RE: **Lot 15 Block 2 Unser Cliffs SAD 227**
6912 Rimrock NW
Grading and Drainage Plan
Engineers Stamp Date 7/16/17 (D10D009)

Based upon the information provided in your submittal received 7/17/17, this plan cannot be approved for Grading Permit until the following comments are addressed.

ENGINEER'S SEAL	6912 RIM ROCK	DRAWN BY WCWJ
	GRADING AND DRAINAGE PLAN	DATE 7-15-17
		21764-LAYOUT-7-14-17
7/16/17		SHEET #
DAVID SOULE P.E. #14522		JOB # 21764

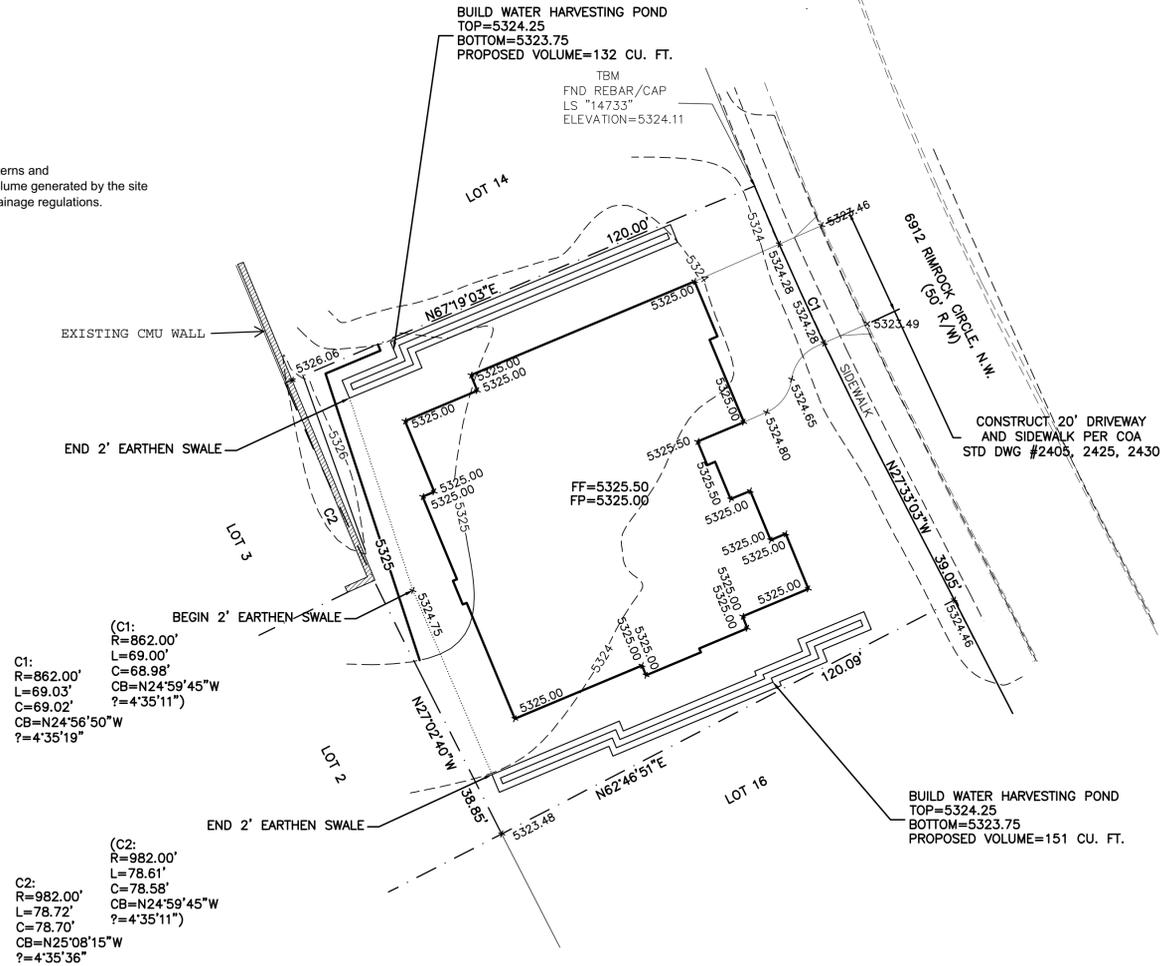
- Provide a statement on the plan stating that this grading plan must be used for the application of any garden/retaining walls.
- Provide a statement that a Pad Certification is required before building permit can be approved.
